Re: **Response to Agency Comments and Work Plan**
Chiu Property
800 Franklin Street
Oakland, California
Fuel Leak Case No. RO0000196
Cambria Project No. 589-1000

RESPONSE TO AGENCY COMMENTS AND WORK PLAN

Chiu Property
800 Franklin Street
Oakland, California 94607
Fuel Leak Case No. RO0000196
Cambria Project No. 589-1000

FIGURE 3

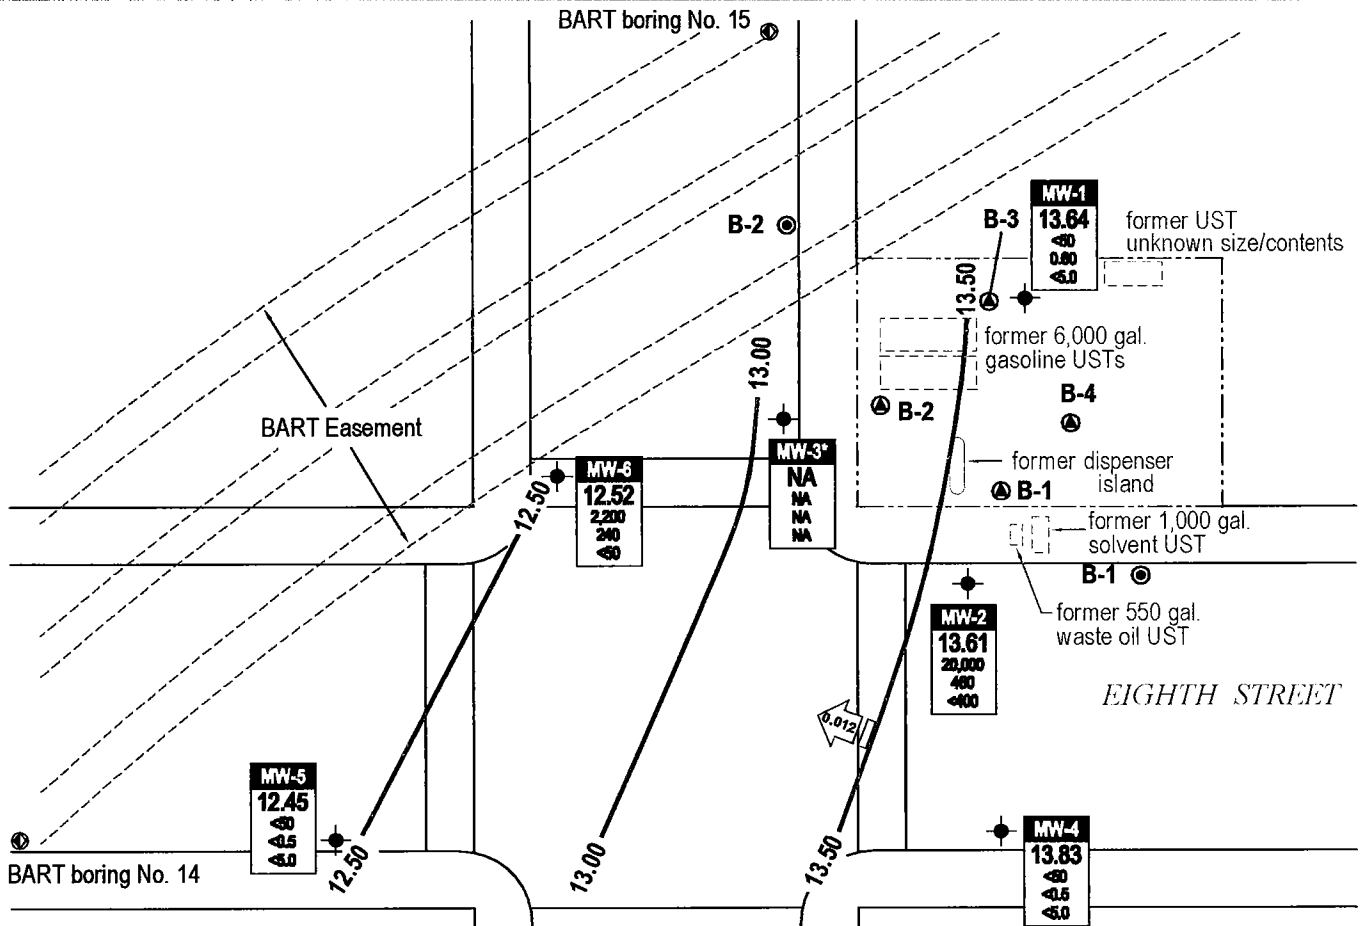
Cambria reviewed previous reports (listed in Section 9.0 References) for apparent groundwater flow direction and hydraulic gradient information. With this information we prepared a rose diagram (see Figure 3). The historic apparent groundwater flow direction has predominantly been towards the northwest. This apparent groundwater flow direction is not consistent with the expected natural flow direction which is towards the Bay, to the southwest. ACEH requested Cambria review BART documents to determine potential effects that the local BART tunnels may be having on groundwater flow.

**Proposed Soil-Vapor
 Sampling Location Plan**

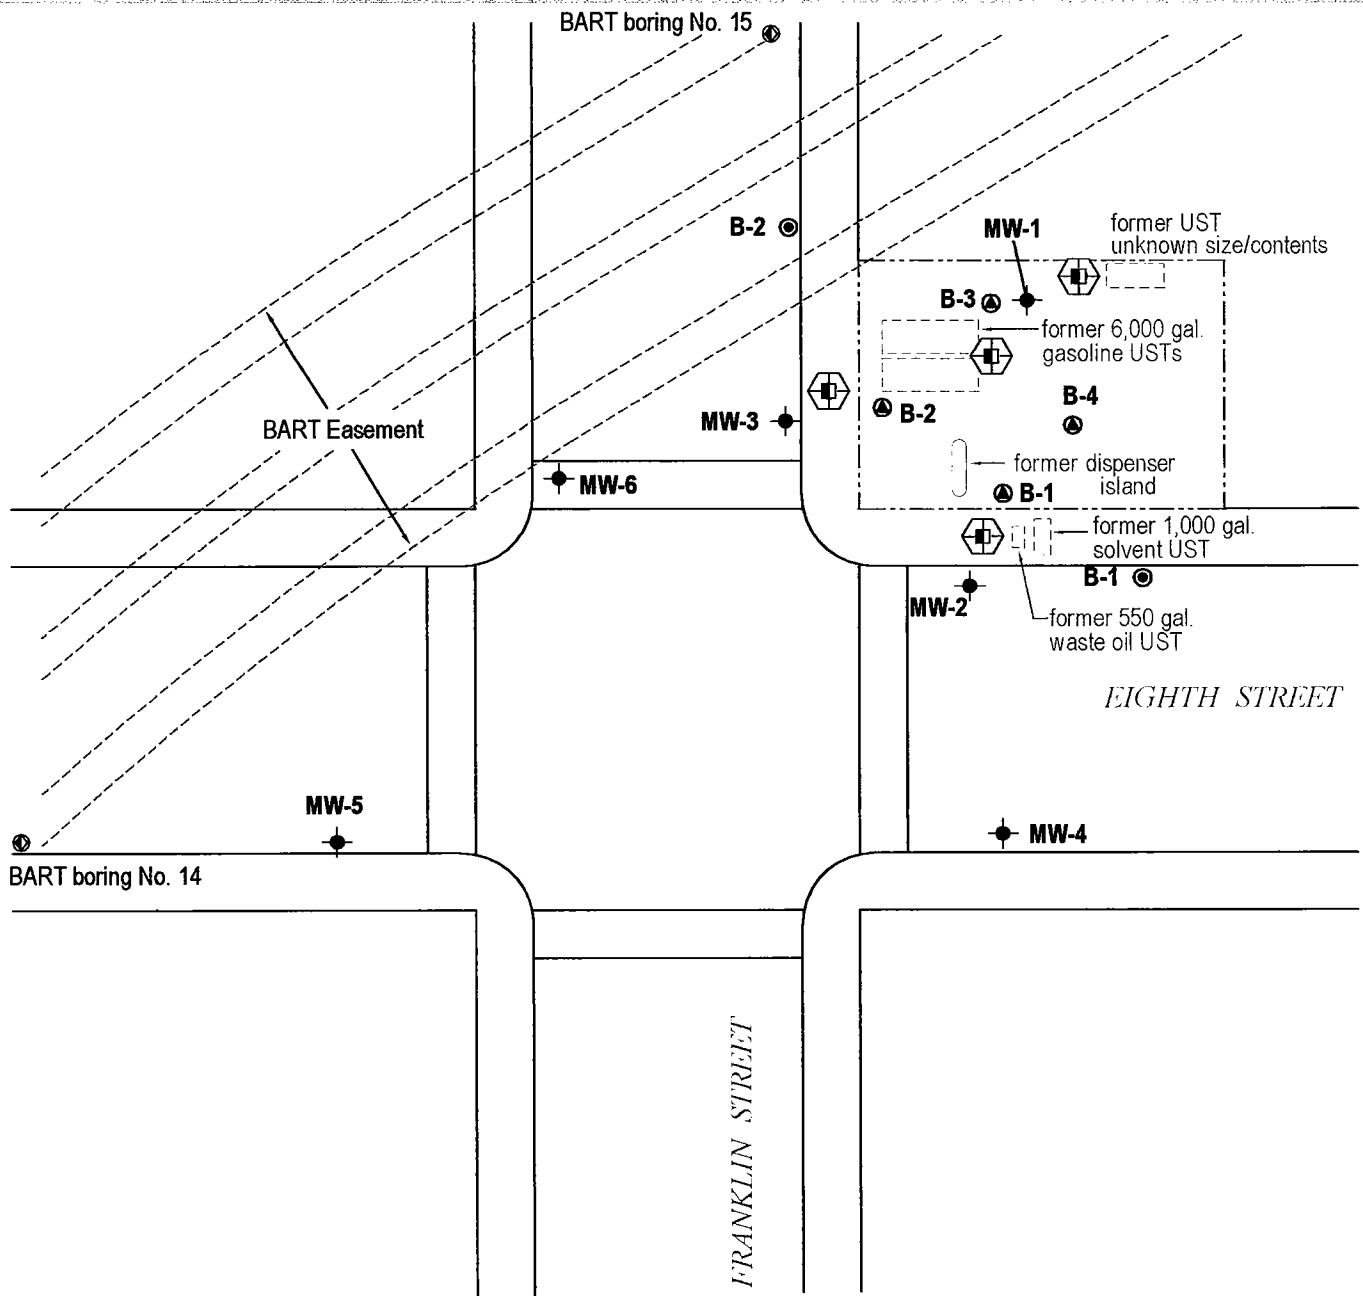
This section presents the scope of work for soil and soil vapor sampling for additional site assessment. In summary, it is currently anticipated that four (4) borings will be used to collect soil samples and soil vapor samples at 5 feet bgs. Soil samples will be analyzed for TPH_{mo} and TPH_d with silica gel cleanup and TPH_g by modified EPA Method 8015; BTEX and MTBE by EPA Method 8021; and 1,2-DCA and chloroform by EPA Method 8260. The soil vapor samples will be analyzed for benzene using EPA Method 8260, TO-15, or TO-14A. Figure 4 presents the proposed soil vapor sampling locations

Proposed borings for soil and soil vapor samples are presented in Figure 4. Actual boring locations may be modified based on subsurface utilities or obstructions. This section presents proposed borings and sampling procedures.

Soil Vapor Sampling Procedures: Soil vapor samples will be collected from each soil vapor borehole, if possible (see Figure 4). The protocols presented in Appendix G *Standard Field Procedures and Soil Vapor Sampling Diagrams* provide general guidance for collecting soil vapor samples.
